CITY OF VANCOUVER

POLICY REPORT  
DEVELOPMENT AND BUILDING

TO: Vancouver City Council  
FROM: Director of Current Planning  
SUBJECT: CD-1 Rezoning - 360 West 1st Avenue

**SHEET NO.:**  
RZ 22  
NOTE: THE DRAWING IS APPROVED AS SHOWN UNLESS  
OTHERWISE SPECIFIED.

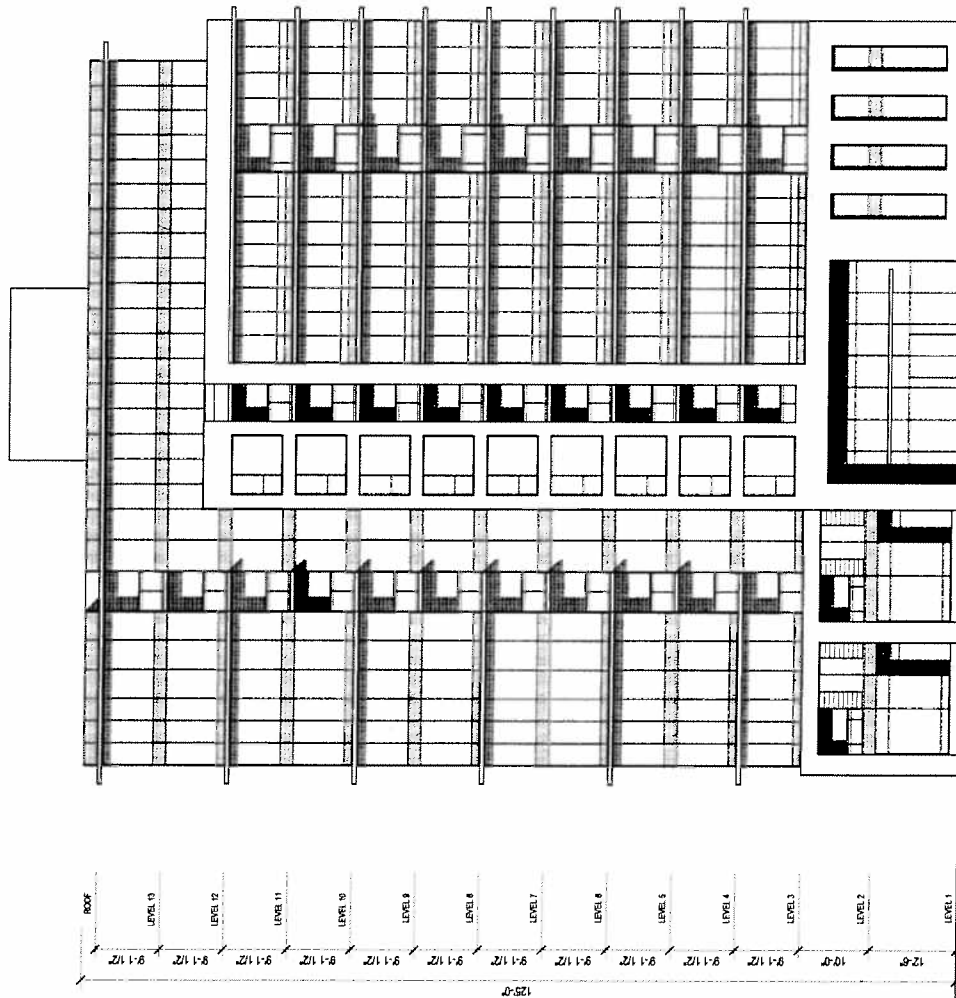
- c. Basing on the handout that MB Rondeau forwarded to us, the Floor-to-floor Height of the building is (13 storeys x 10 ft) 130 ft. maximum. The purposed, as based on sheet #RZ2.2 of the submitted plans is 122.92 ft. --- therefore, the proposed floor-to-floor height of the building is ok.
